JINDAL ALUMINIUM LTD.

PARTY'S NAME	BETA INDUSTRIAL EST.,DUBAI
PARTY'S DRAWING No.	AS PER SKETCH
ALLOY & TEMPER	HE9 WP (6063 T6)
LENGTH	5850 mm.
DESCRIPTION	DIFFUSER CORE

SCALE	1:1 & 2:1
WEIGHT kg/m	0.212
SECTION No.	26638
DRAWING No.	26638

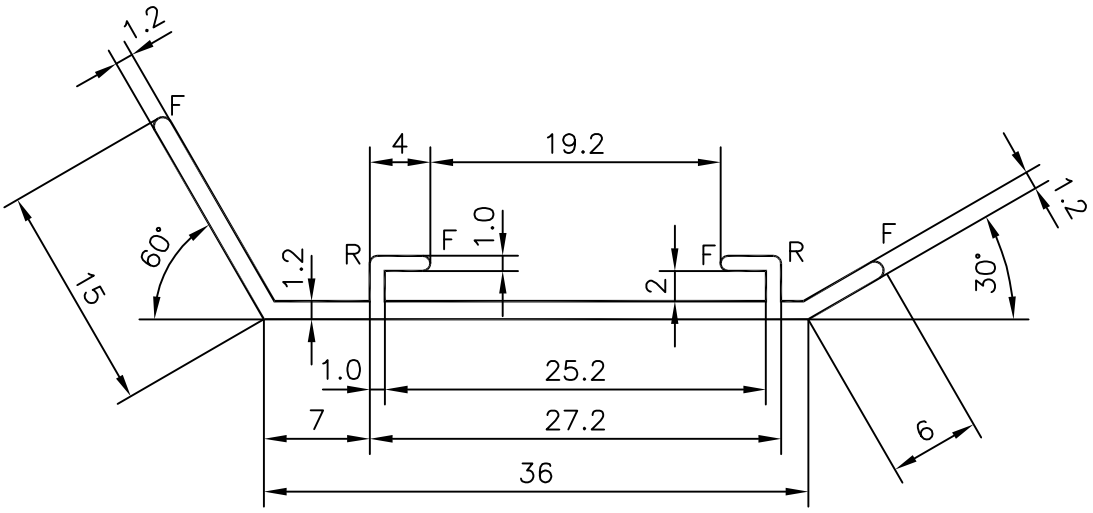
ISSUE	DESCRIPTION	CHD BY	APPD BY
2	TOLERANCE ADDED ON DIMENSION 2±0.20 AND ENSURE THAT, IT SHOULD NOT BE LESS THAN 1.80 mm., AS Sh. KRR DISCUSSED WITH THE PARTY DURING HIS VISIT TO DUBAI ON 26-10-97
